Techstream Cannot Command Self-EVAP Test

Service Category Engine/Hybrid System

Section Emission Control

YEAR(S)	MODEL(S)	ADDITIONAL INFORMATION
2016 - 2018	Land Cruiser

Figure 1.

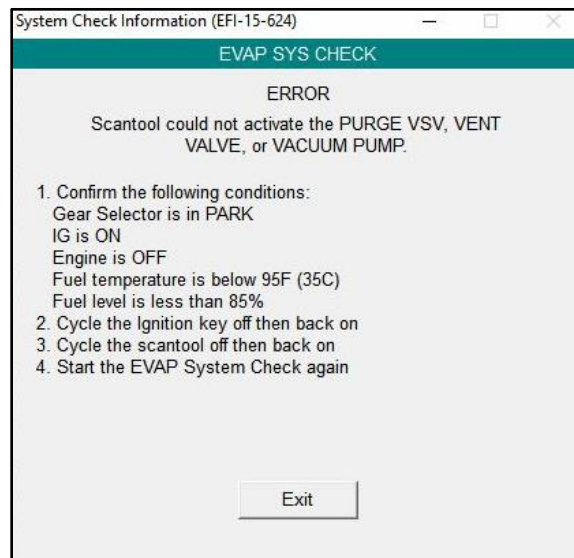
Some 2016 – 2018 model year Land Cruiser vehicles may exhibit a condition where the Techstream EVAP System Check Utility will not run as shown. The Transmission Control Module (TCM) logic has been modified to address this condition. Follow the Repair Procedure in this bulletin to address this condition.

Figure 2. Location of Authorized Modifications Label for 2016 – 2018 Land Cruiser

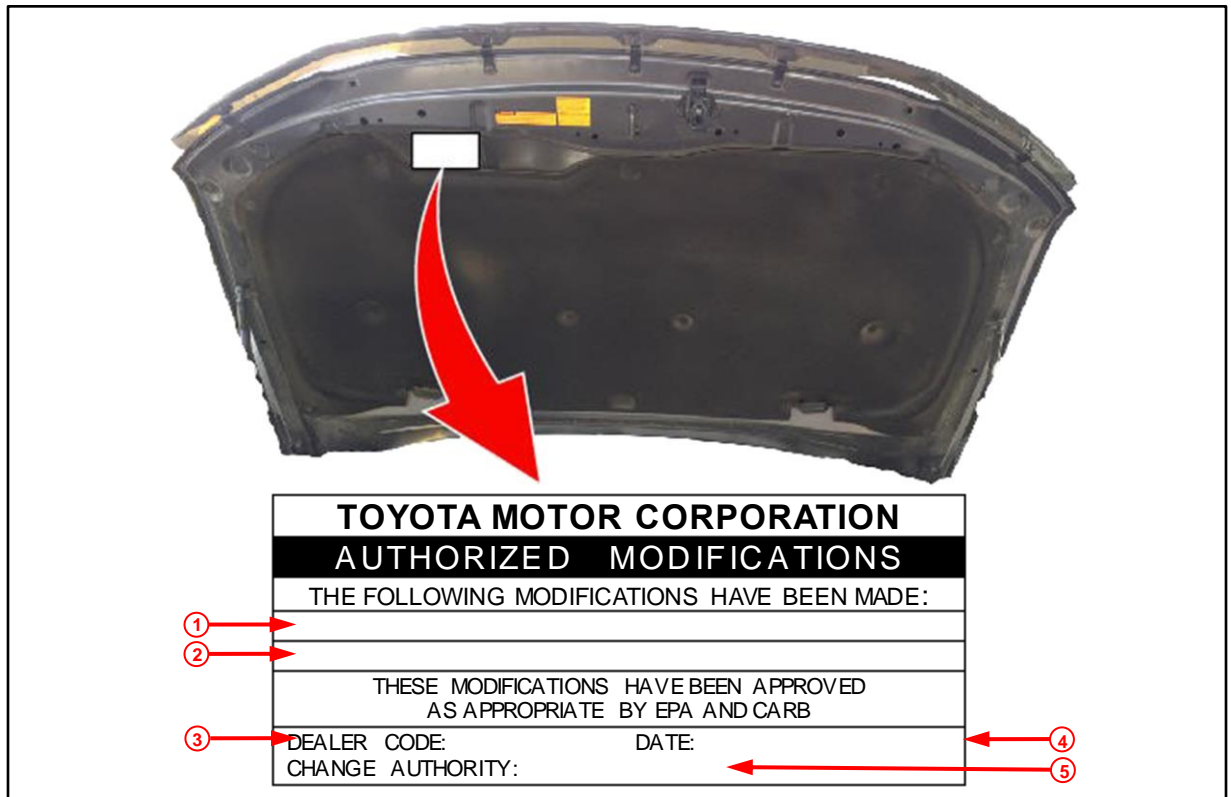
4. Prepare and install the Authorized Modifications Label.
 - A. Using a permanent marker, enter the following information on the label:
 - TCM part number [Refer to the **Parts Information** section for the **NEW PART NUMBER**]
 - Calibration ID(s) [Refer to the **Calibration Information** section for the **NEW CALIBRATION ID**]
 - Dealer Code
 - Repair Date
 - Change Authority [**This bulletin number**]

Install the Authorized Modifications Label to the vehicle at the location shown in Figure 2. The Authorized Modifications Label is available through the MDC, P/N 00451-00001-LBL.

Figure 3.

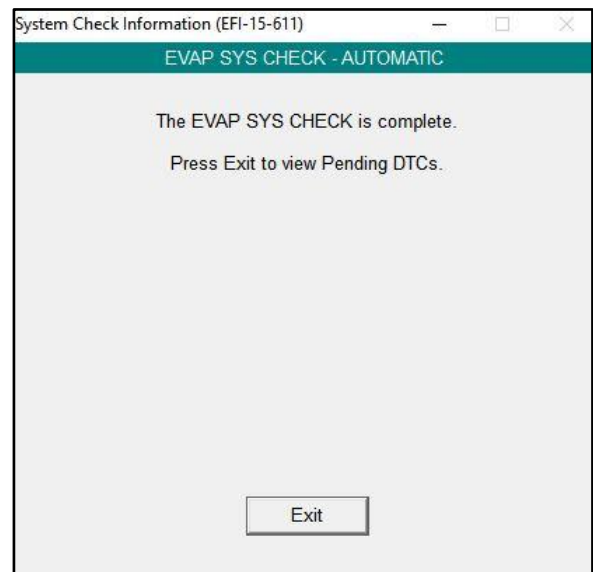
5. Connect Techstream to the vehicle and run the EVAP System Check Utility (*Engine and ECT – Utility – Evaporative System Check*).
Confirm proper operation as shown.
